Lake Monona Waterfront

Sasaki Comments Response to Ad-hoc Committee's Design Comments - 09/14/23 - revised

PHASING DIAGRAM- LAW PARK LEDGE (L)

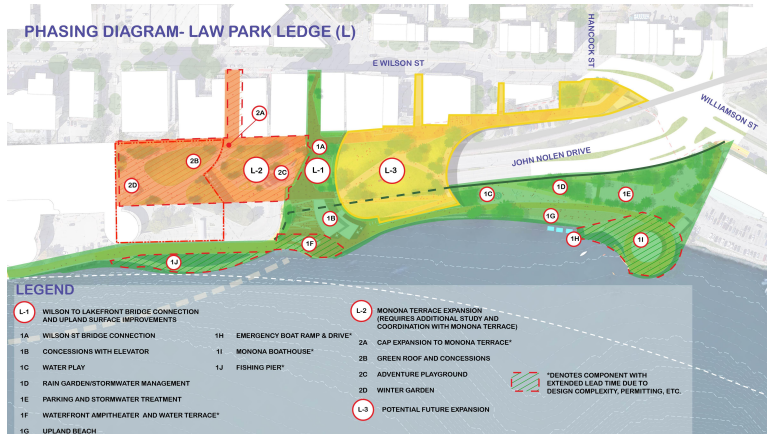
a. Define boundaries between phases

b. Clarify phasing/expansion language

Sasaki Response: Approved. Please see next page for phasing graphics.

Sasaki Response: Approved. We are suggesting to keep our zones named per our phasing plan: L1, L2, L3. Please see the next page for phasing graphics.

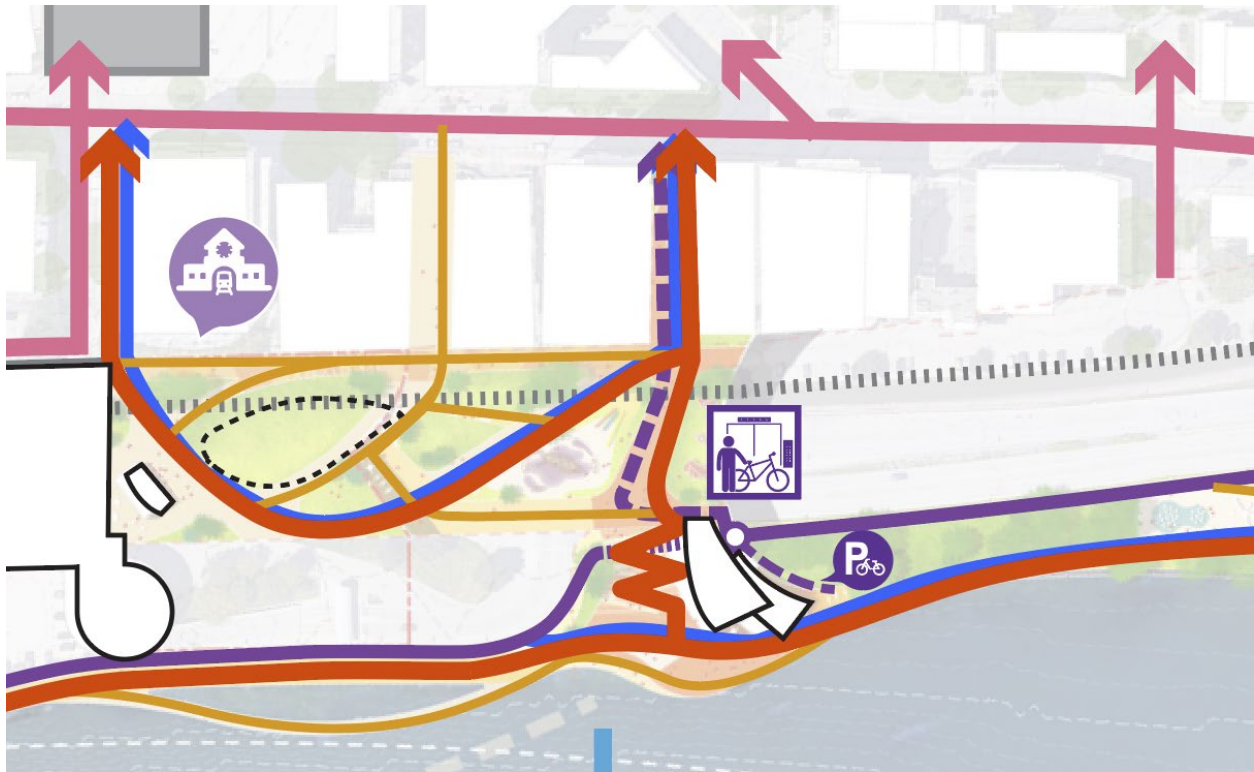
- c. Clarify the proposed bike route connection from E. Wilson Street to the lakeshore

Sasaki Response: Approved with comments. Please see screenshot attached. It will be walk-your-bike zone from E. Wilson Street to the lakeshore (see below) via Law Park Ledge Capped Park (L-1 initial phase).

- **Pedestrian primary path (red)** discourages bike riding (bike walking zone only).
- People can walk their bikes to the new multi-purpose elevator/ramp to get to the bike racks near the amphitheater, or the **dedicated bike lane (purple)** if they want to head somewhere else.

(Top: Refined)

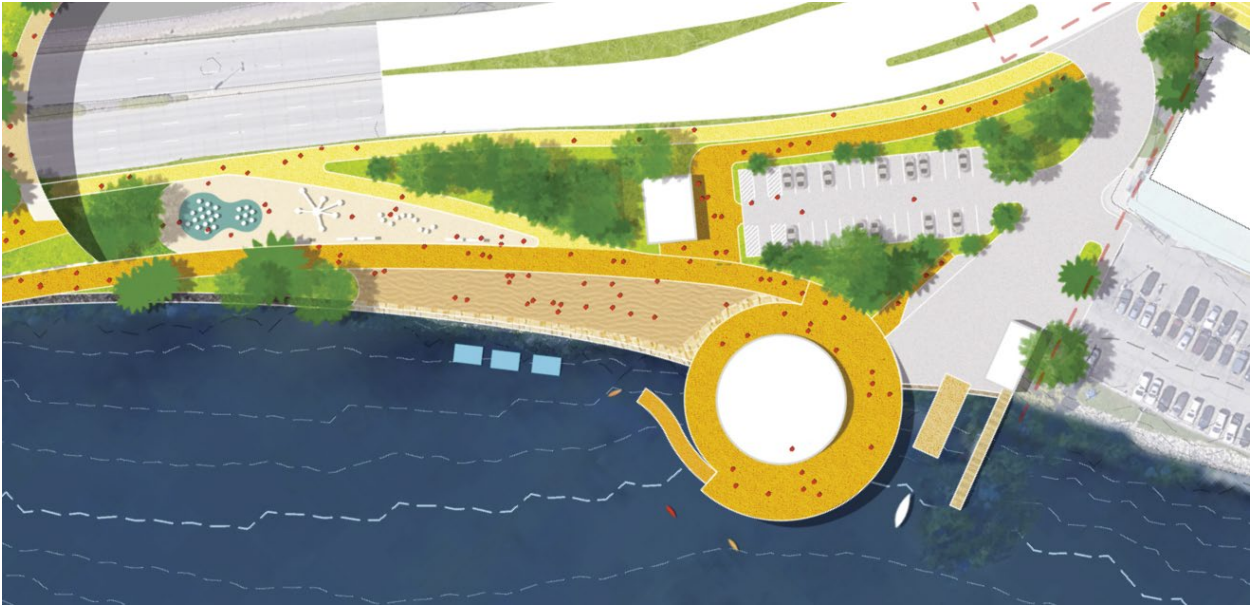
- d. Reconcile the corner by Machinery Row (parking, pier, emergency boat ramp)

Sasaki Response: Approved with Comments. See updated design (below). The new scheme moved the community center further south to make space for the emergency boat ramp and existing floating pier. It will also allow 3-point turn for vehicles near the controlled ramp, instead of backing in.

- The parking geometry also changed to allow better pedestrian/vehicular circulation, and a drop-off space in front of the community center. The refined design consolidated the park space.

8/23 version

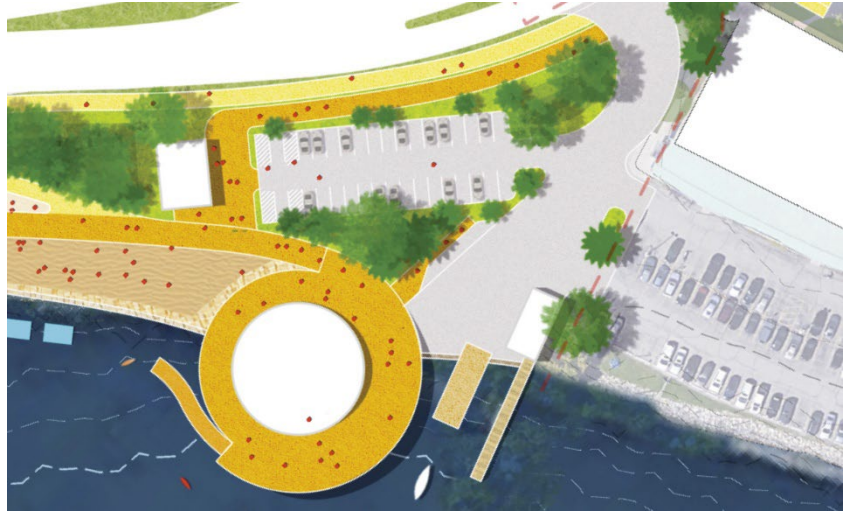
- k. I'm still in favor of reducing the size of the parking at the boathouse to the minimum needed for emergency access and drop off.

Sasaki Response: Approved with Comments. We are decreasing the size of the parking lot from the existing condition of 57 regular parking spaces plus 1 accessible parking space, to the proposed 26 regular parking spaces plus 4 accessible parking spaces.

Refined (less parking + separate circulation systems)

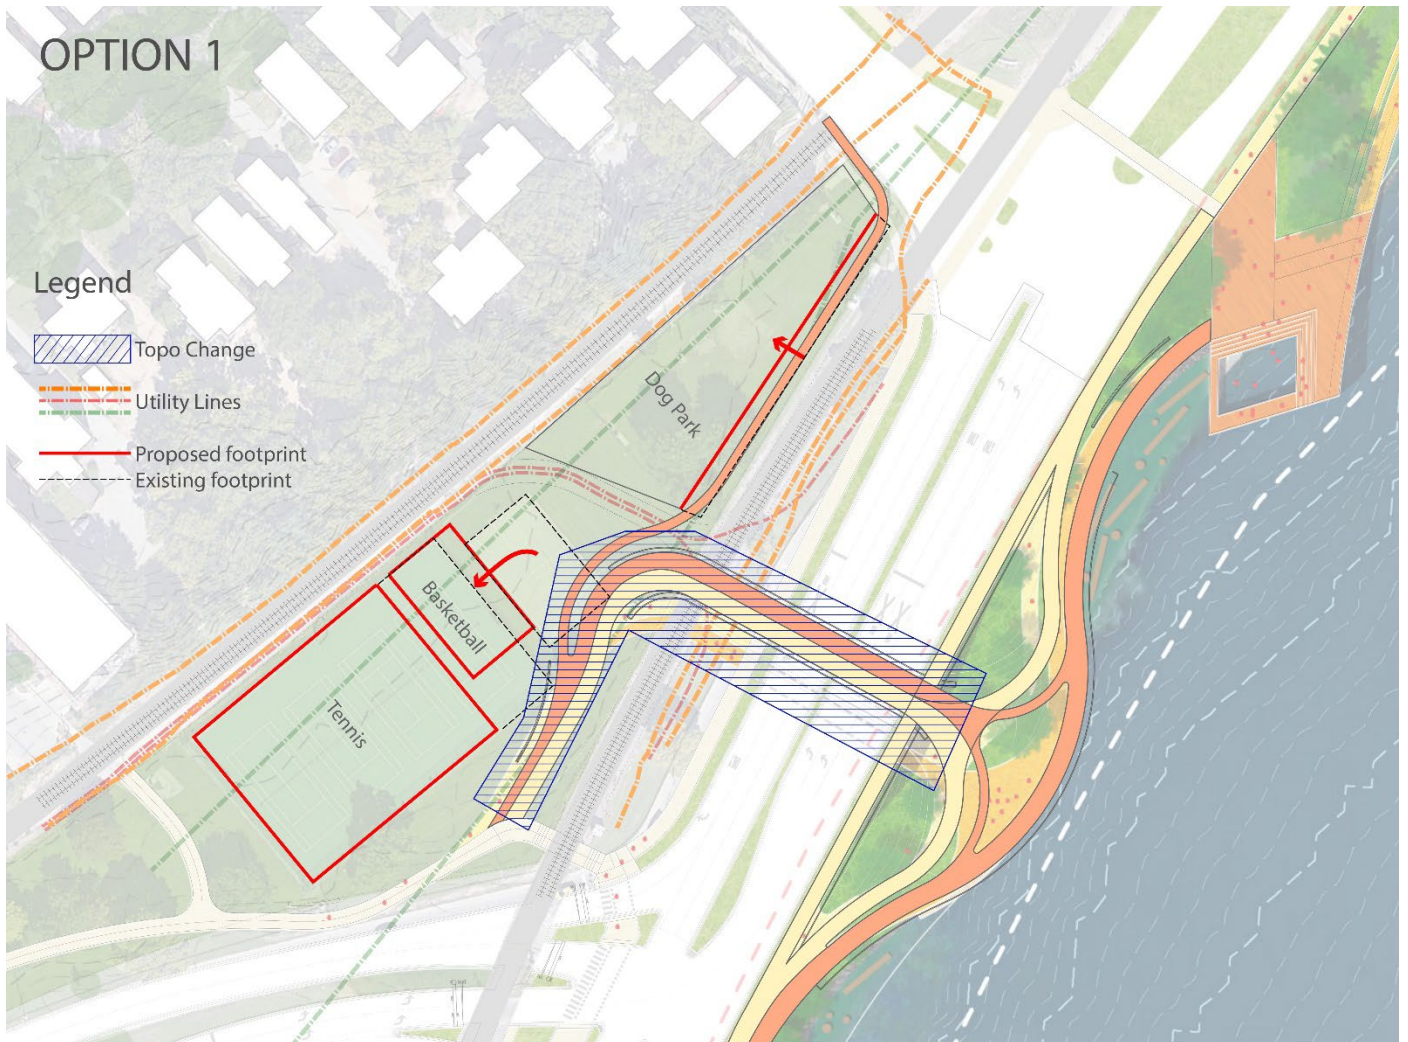
- a. Is a lake-access pool included in the proposed deck? Or does it simply provide access to the lake below?

Sasaki Response: TBD. We received several different comments on this one, we would like to defer to the committee on providing a finalized direction for the design team.

- Please see LMW Detailed MP_Scale Comparison - Lake Lounge Plaza if you are interested, for scale comparisons and some precedent images.
- We will provide steps to access water/ice in either direction.
